Consolidated Reply of Pre-Bid Queries

Final consolidated Reply of Employer (NHPC Ltd.) on Techno-Commercial queries (from the prospective bidder through representation at GEM Portal)

N.O.W.: Insurance Coverage for the GIS equipment under EAR, third party liability and terrorism risk for the work “Supply, Erection, Testing & Commissioning of 420 KV GIS, 400 KV Outdoor Pothead Yard, 400 KV XLPE Cables and associated accessories for Teesta V Power Station.

GEM Bid No.: GEM/2025/B/6288791 Dated: 29.05.2025.

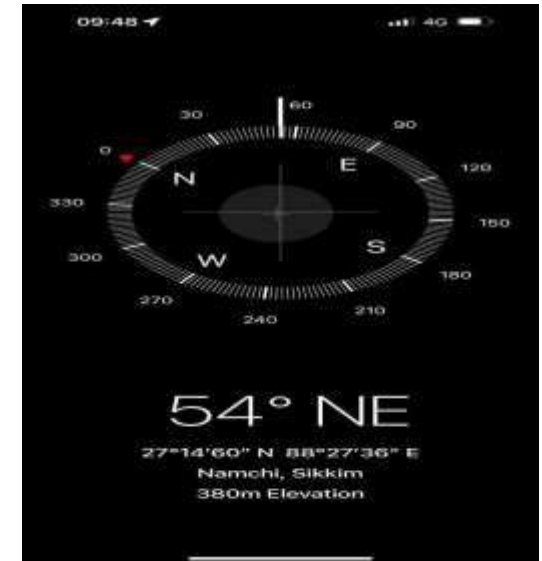
SL. N.	Tender Reference	Tender Description/Existing clause as per Bid Documents	Pre-Bid query (Techno-Commercial) received	Reply of NHPC Ltd.
1	GeM Bid Details (Custom Bid Documents dated 29.05.2025).	Brief description of the project	Please provide clarity on the following point: Location coordinates or kmz File where the substation is being constructed.	Exact location coordinate is as below:-

27°14'60" N 88°27'36" E

The GIS building is being constructed in front of the main access of the Power House, within close proximity and inside the project area.
